SUNDRY NOTICES AND REPORTS ON WELLS

San Juan 32-5 Unit #21

Energen Resources would like to make the following changes to the San Juan 32-5 Unit #21 as follows:

Revised Plan

Project: S/2 Sec.22, T32N, R6W
 Site: Eul Canyon
 Well: San Juan 32-5 Unit #21
 Wellbore: Revised Plan
 Plan: Final (San Juan 32-5 Unit #21/Revised Plan)

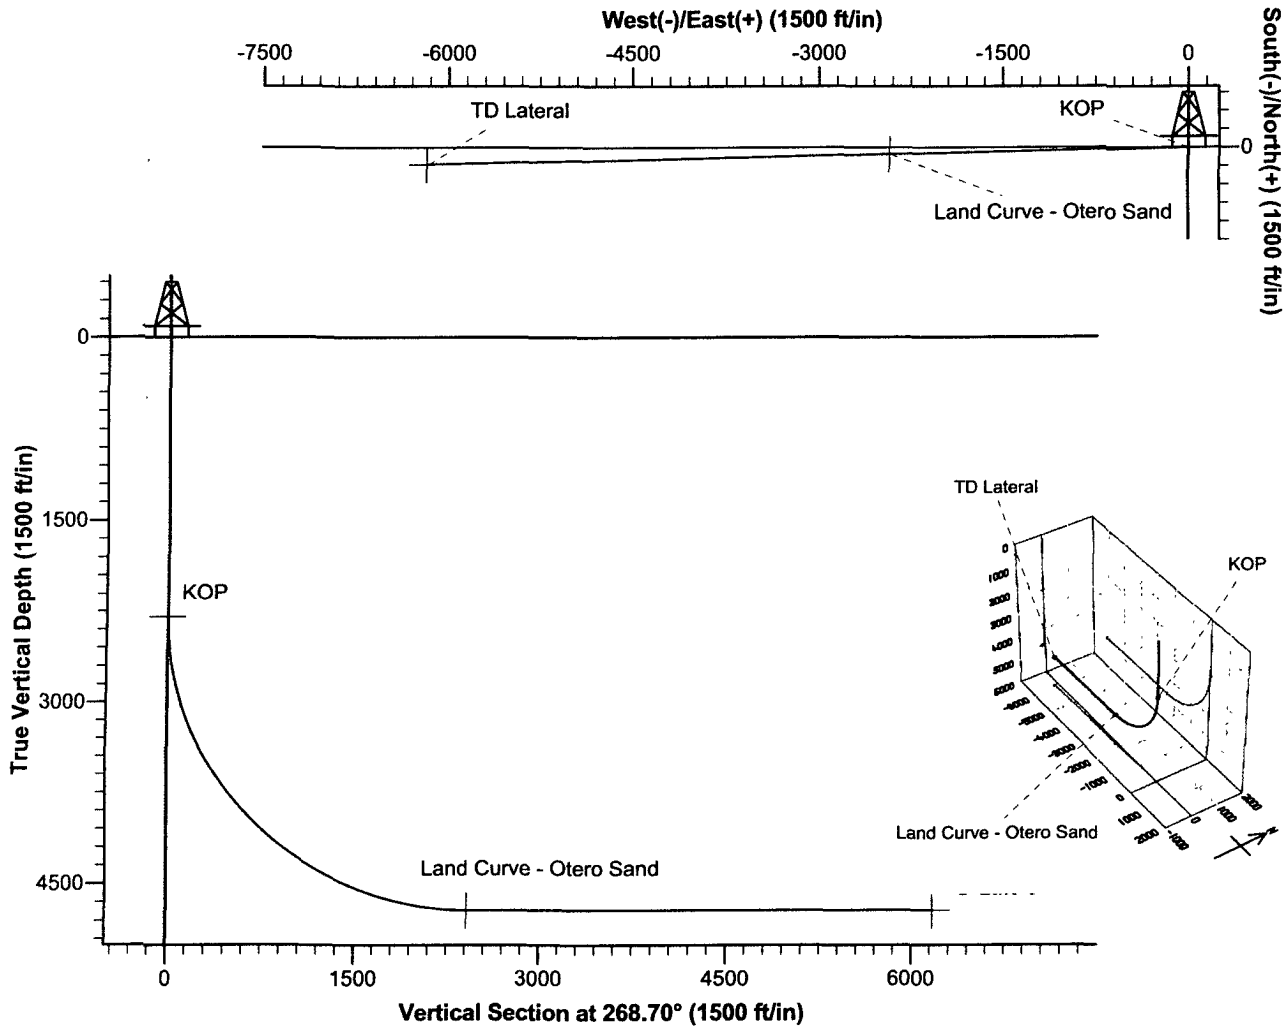
-Change the TVD and MD of the well to 4722' TVD, 9842' MD and change the target formation from the Navajo City (Upper Cliffhouse) to the ~~Otero formation~~ Cliff House.

-Change the setting depth of the 7" intermediate to 6125' MD (4717' TVD) and cement with 875 sks lead followed by 150 sks tail.

-Change the production liner to 4 1/2" 11.60 ppf L-80 LTC and set from 6025'-9842' MD (4717'-4722' TVD).

Attached is a revised directional and operations plan.

Sec	MD	Inc	Azi	TVD	+N/-S	+E/-W	DLeg	TFace	VSec	Target
1	0.0	0.00	0.00	0.0	0.0	0.0	0.00	0.00	0.0	
2	2300.0	0.00	0.00	2300.0	0.0	0.0	0.00	0.00	0.0	KOP
3	6096.6	90.00	268.70	4717.0	-54.8	-2416.4	2.37	268.70	2417.0	Land Curve - Otero Sand
4	9849.2	90.00	268.70	4717.0	-140.0	-6168.0	0.00	0.00	6169.6	TD Lateral
